Wisconsin Department of Transportation

Proposal #10:

1130-66-71, WISC 2027011
Appleton - De Pere
I-41 Mainline, Holland-CTH N
IH 41
Outagamie County

This is Addendum No. 01, which provides for the following:

PROJECT NO: 1130-66-71	HWY: IH 41	COUNTY: OUTAGAMIE	PERMANENT SIGNING	SHEET 280	E

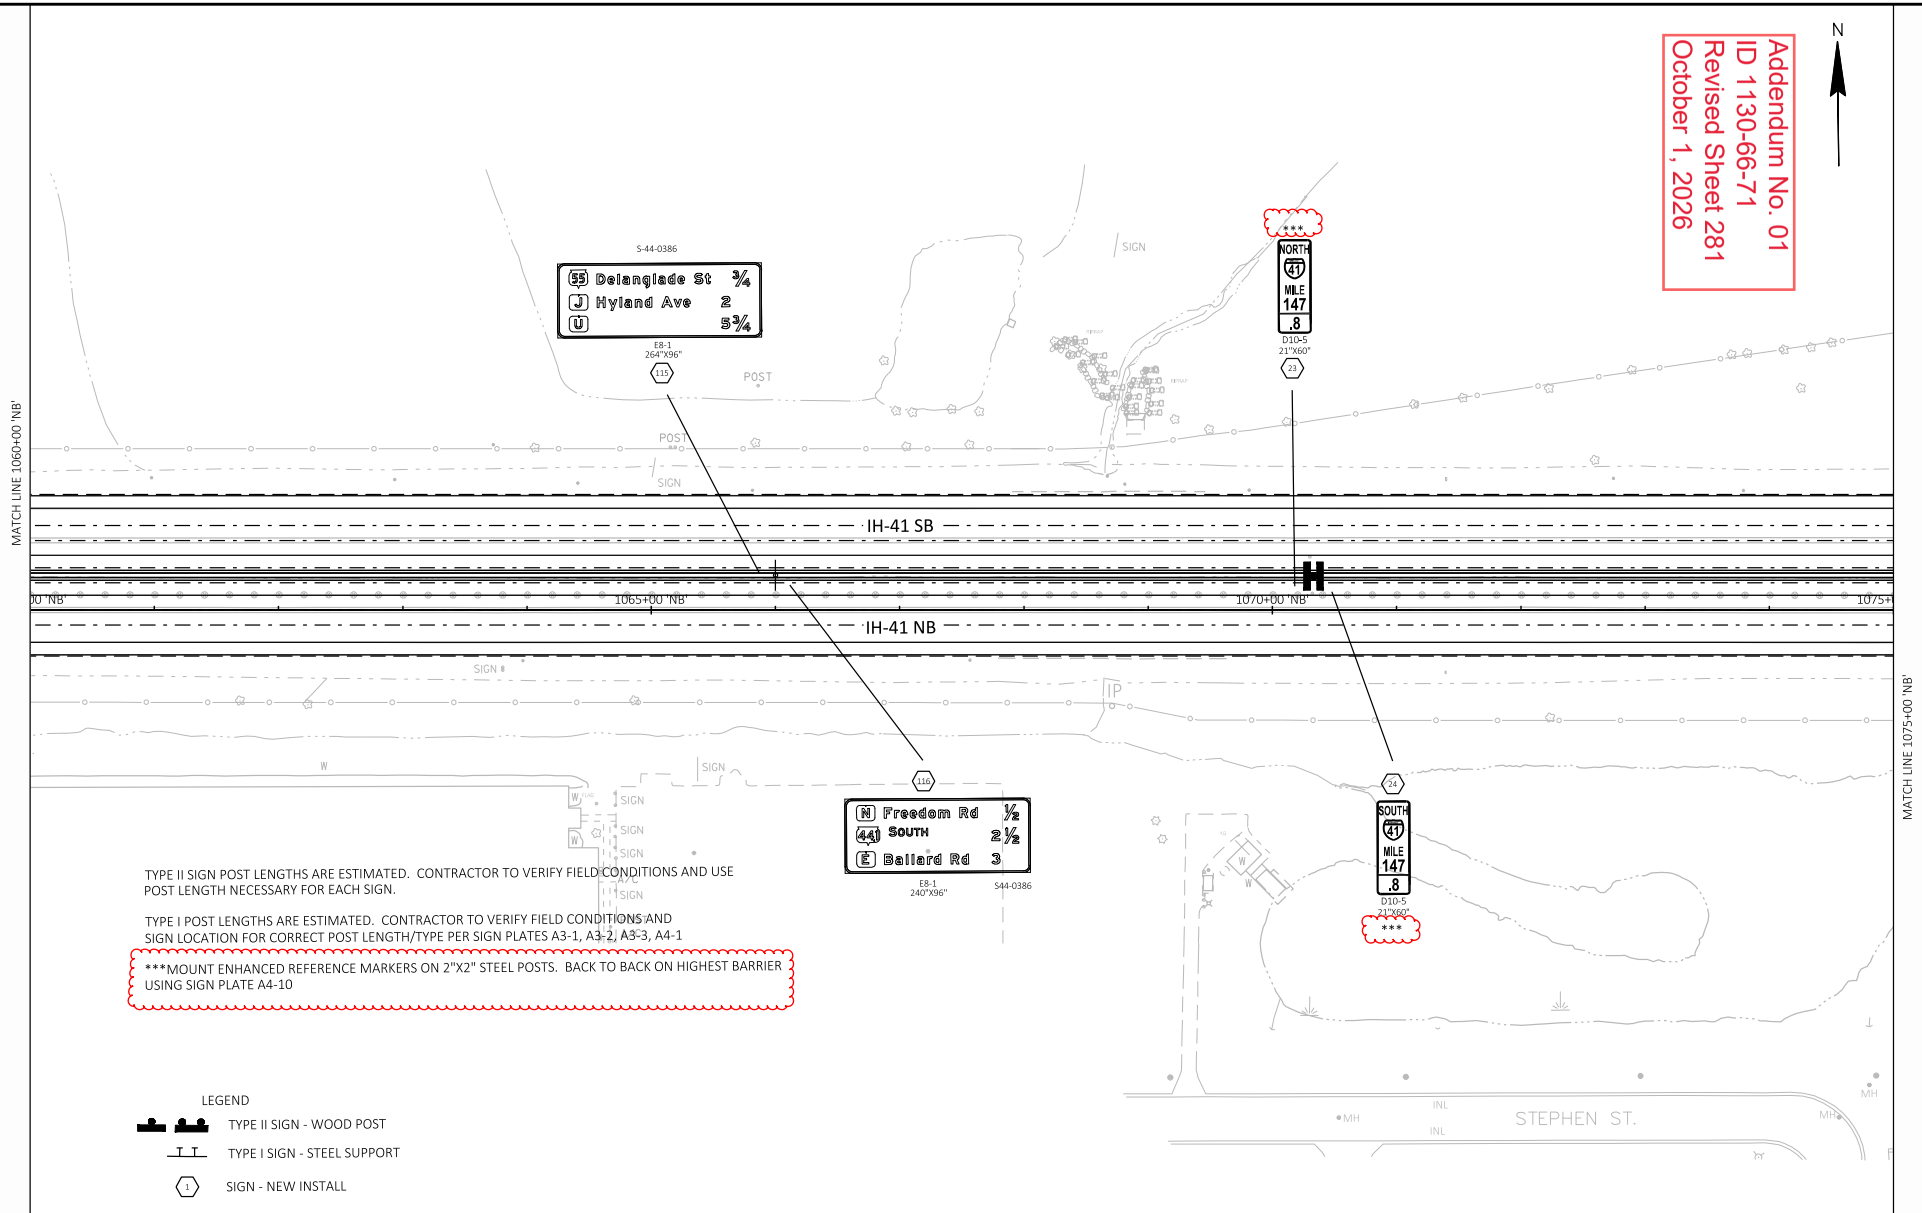
Revised Plan Sheets (1130-66-71)	
Plan Sheet	Plan Sheet Title (brief description of changes to sheet)
274-281	Permanent Signing (added note to mount Enhanced Reference Markers on 2”x2” steel posts)
329	Traffic Control General Notes (added note to indicate temporary ramp pavement structure)
437	Miscellaneous Quantities (added Excavation Common quantity for Relief Trenches)
438	Miscellaneous Quantities (revised Base Aggregate Dense 1 ¼-Inch, Select Crushed Material, and Geotextile Type SAS)
439	Miscellaneous Quantities (Revised Tack Coat quantity in the Asphaltic Items Table)
456	Miscellaneous Quantities (added notes to Type I signing table, moved Type II signing table to new sheet, Revised Type II signing table to include Posts Tubular Steel 2x2-Inch x 8-FT)

***MOUNT ENHANCED REFERENCE MARKERS ON 2"X2" STEEL POSTS. BACK TO BACK ON HIGHEST BARRIER USING SIGN PLATE A4-10

PROJECT NO: 1130-66-72	HWY: IH 41	COUNTY: OUTAGAMIE	PERMANENT SIGNING	SHEET 336	E

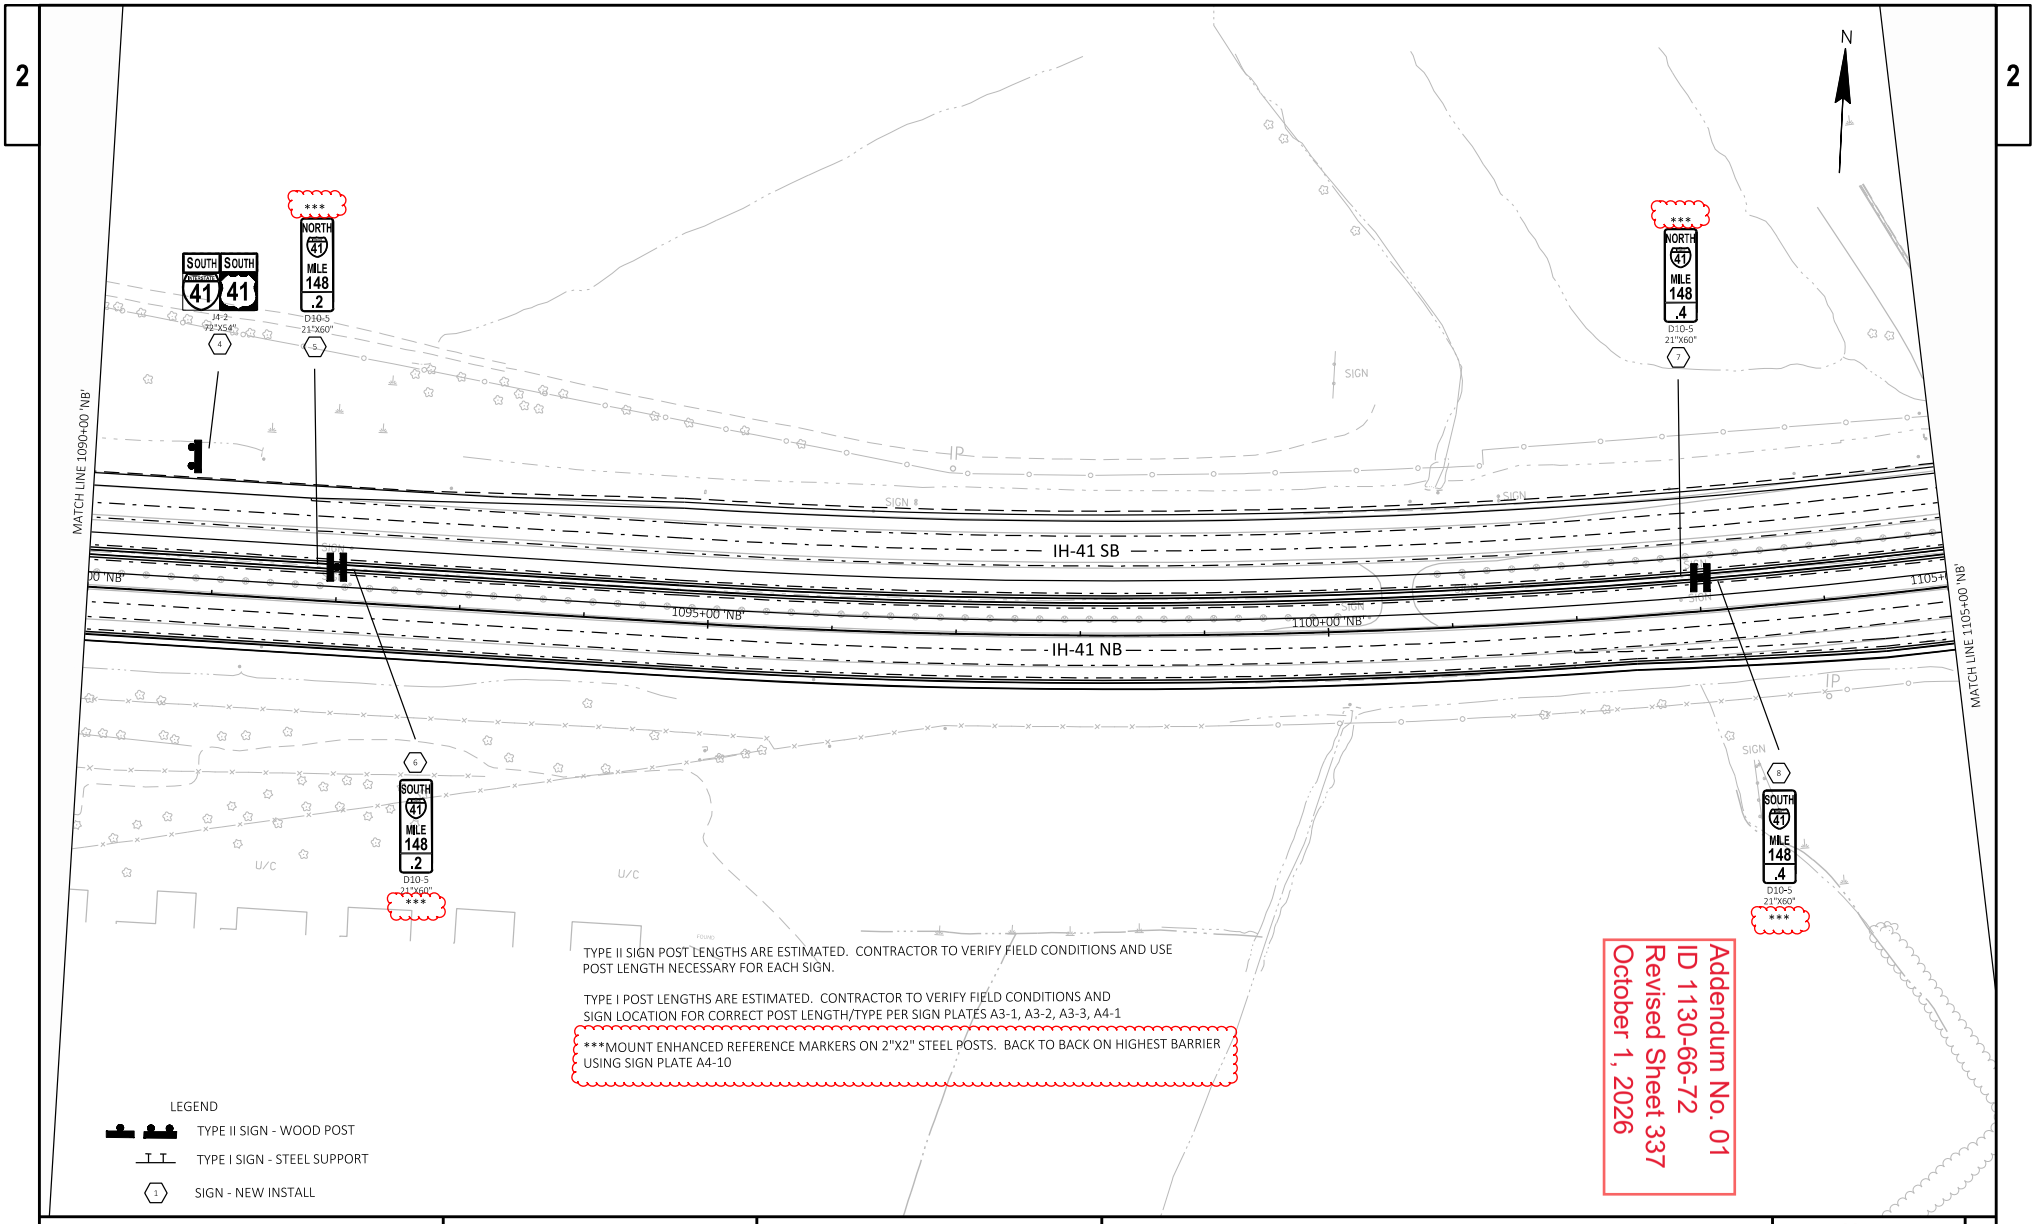
Revised Plan Sheets (1130-66-72)	
Plan Sheet	Plan Sheet Title (brief description of changes to sheet)
336-347	Permanent Signing (added note to mount Enhanced Reference Markers on 2”x2” steel posts)
647	Miscellaneous Quantities (Updated Earthwork Summary Table to add DGD Surcharge to Stage 1A)
649	Miscellaneous Quantities (Added EBS Backfill row)
651	Miscellaneous Quantities (Revised Tack Coat quantity in the Asphaltic Items Table)
672-673	Miscellaneous Quantities (Revised Type II signing table to include Posts Tubular Steel 2x2-Inch x 8-FT)
679	Miscellaneous Quantities (Added table for CTH J and CTH OO intersection signing and marking)
1080	B-44-0041 revisions
1081-1082	B-44-0043 revisions
1284	Earthwork (Added DGD end area table)

PROJECT NO: 1130-66-72	HWY: IH 41	COUNTY: OUTAGAMIE	PERMANENT SIGNING	SHEET 341	E

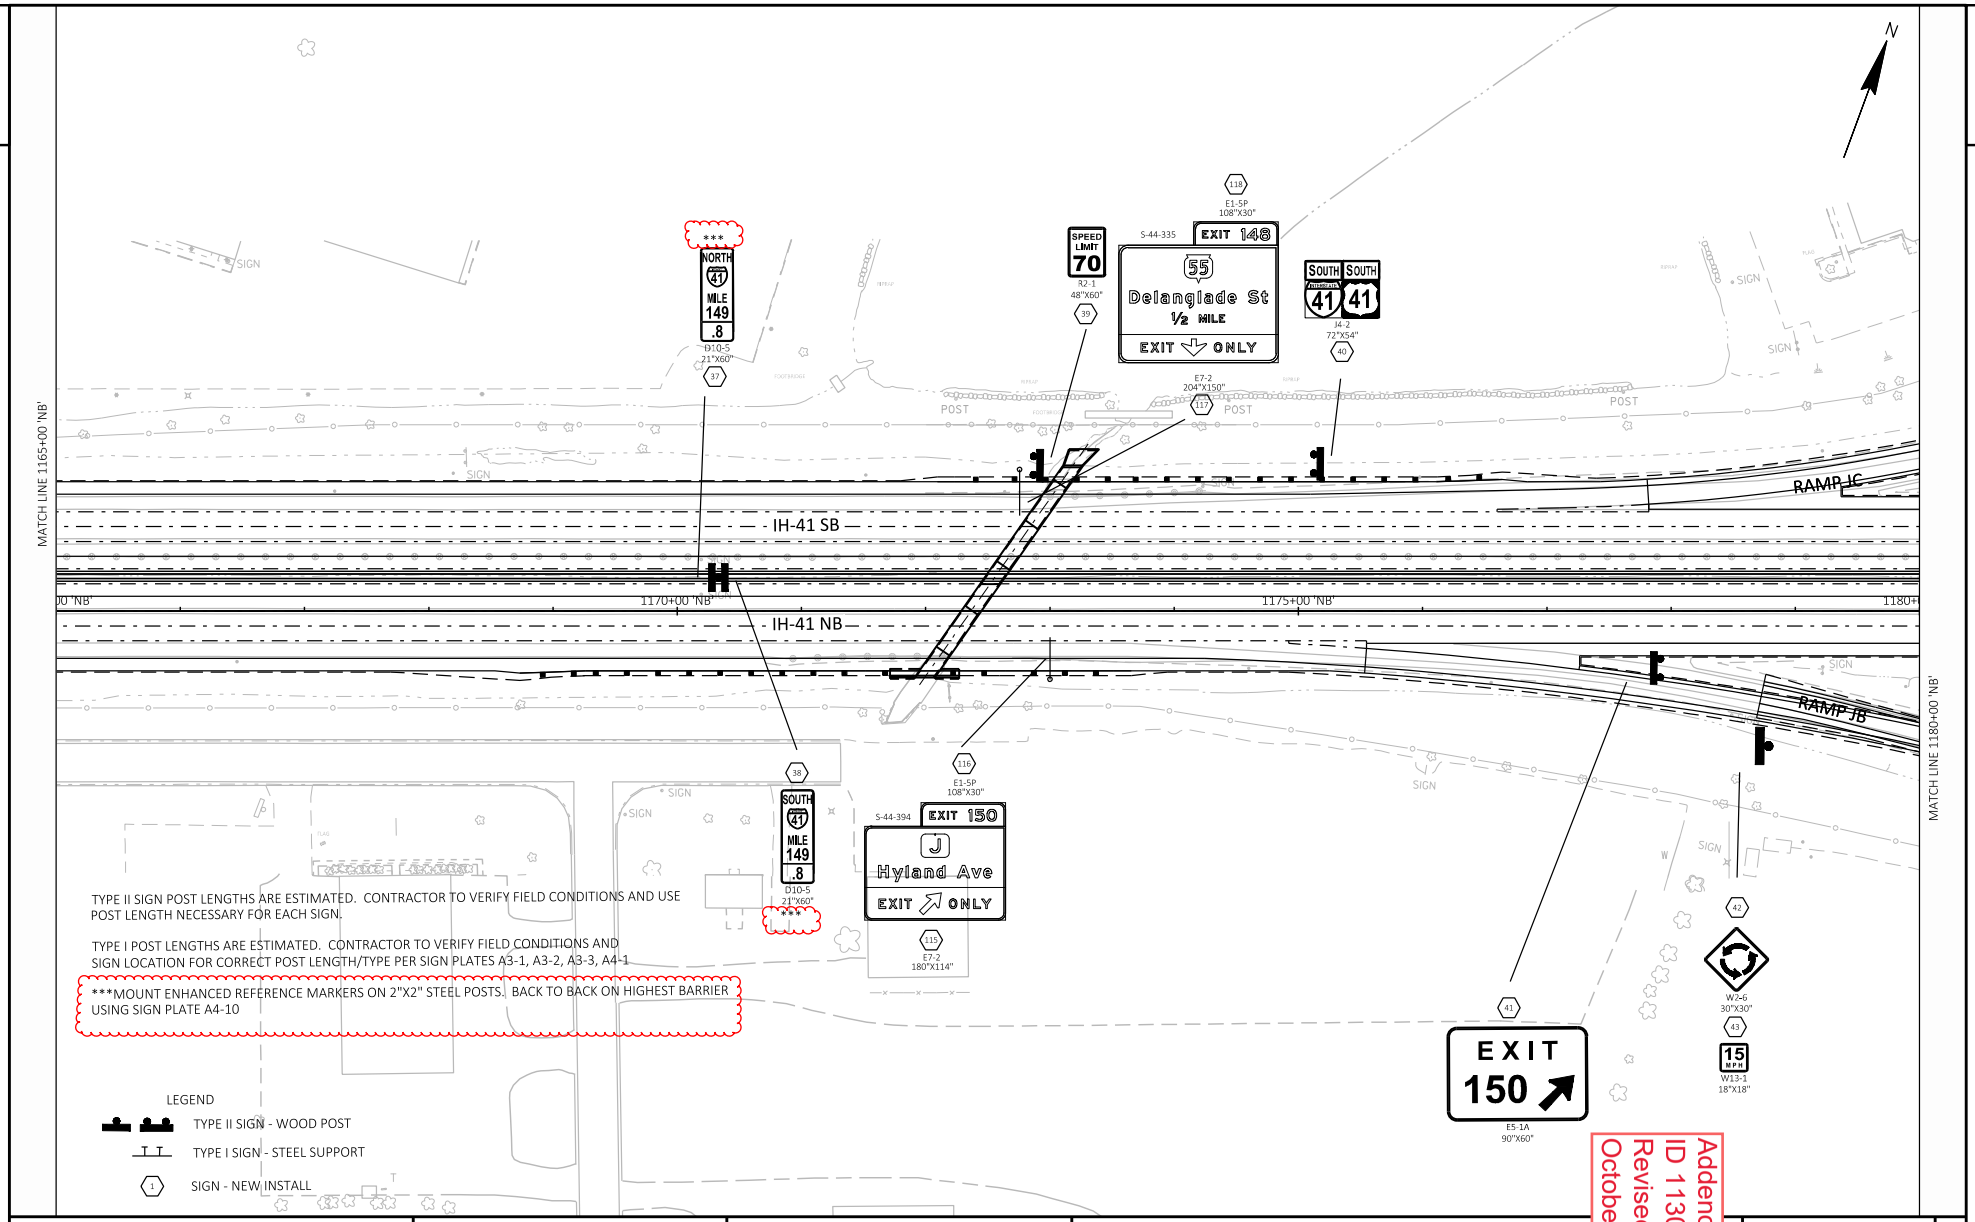
***MOUNT ENHANCED REFERENCE MARKERS ON 2"X2" STEEL POSTS. BACK TO BACK ON HIGHEST BARRIER USING SIGN PLATE A4-10

PROJECT NO: 1130-66-72	HWY: IH 41	COUNTY: OUTAGAMIE	PERMANENT SIGNING	SHEET 342	E

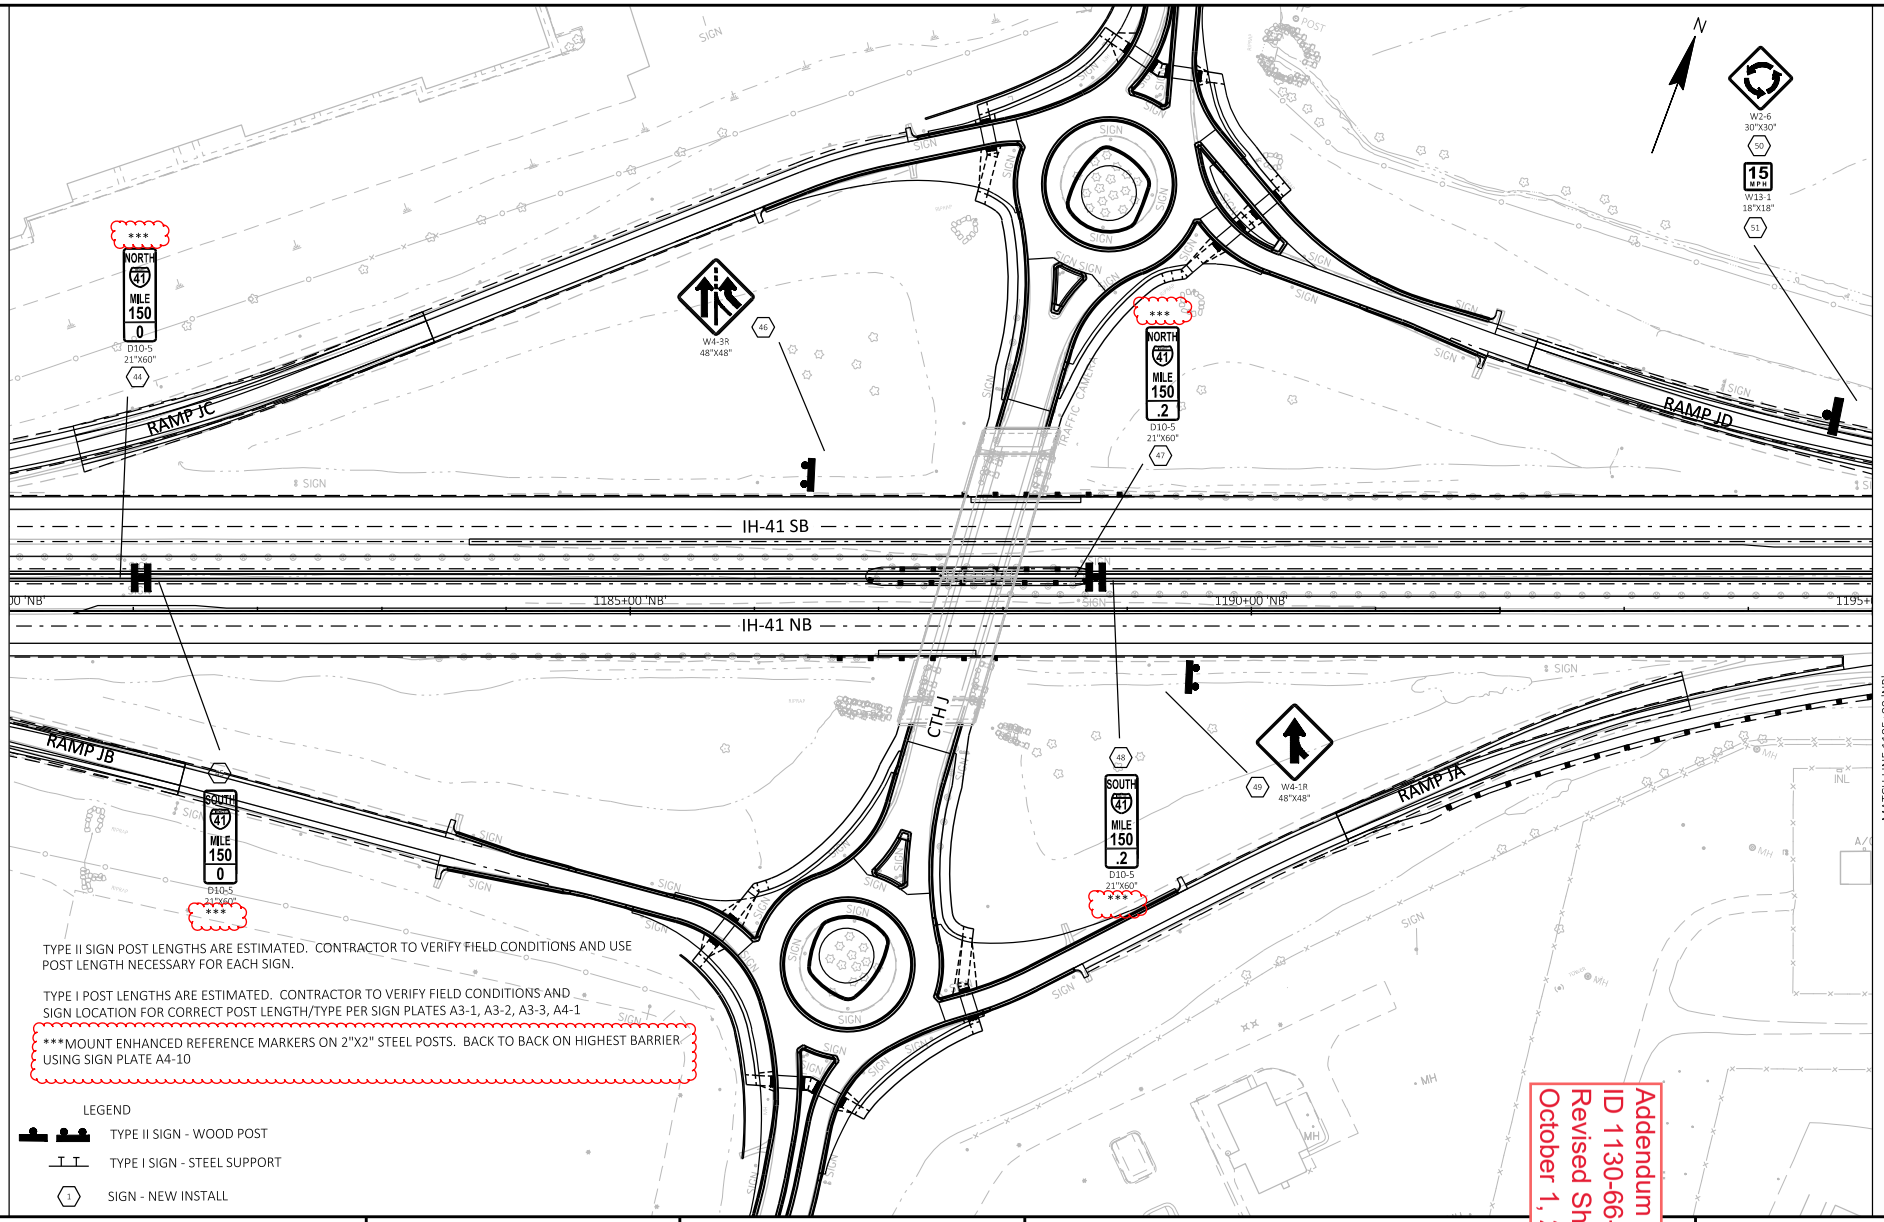
***MOUNT ENHANCED REFERENCE MARKERS ON 2"X2" STEEL POSTS. BACK TO BACK ON HIGHEST BARRIER USING SIGN PLATE A4-10
